BULLETIN DETAILS

Model Affected: J3 Backrest Range

Bulletin Subject: Improvement to J3 Backrest Range

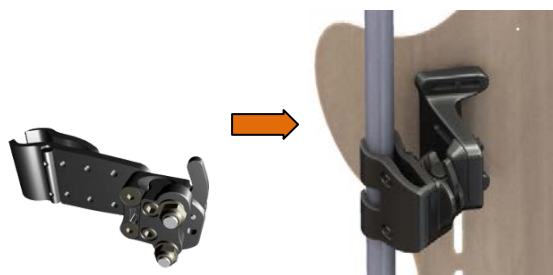
Feature	Benefit
<p>New Compact Mounting hardware</p>  <p>Old style New Style</p>	<p>Re-designed to meet the needs of active users:</p> <ul style="list-style-type: none"> ✓ 25% lighter than the current 2-point JAY J3 quick release hardware ✓ The lightest backrest mounting hardware available in the market ✓ Easier to fit and adjust ✓ Adjustable in width (5cm), depth (3cm), angle (+/- 22°), and height (by movement of brackets attached to shell or movement of backposts clamps) ✓ Easily fits majority of backpost tubes ✓ Longer clamp bolts – prevents clamp separation when fitting to wider back post tubes (20 and 30mm long bolts are supplied as standard) ✓ 136kg max user weight ✓ Transit tested and approved <p>The new compact mounting brackets will be included with every new Low thoracic and Mid thoracic J3 backrest but also available as a spare part.</p> <p>The old style hardware (code J3EUSH) will still be available as a spare part for the next 5 years.</p> <p>Please refer to http://parts.sunrisemedical.eu</p>
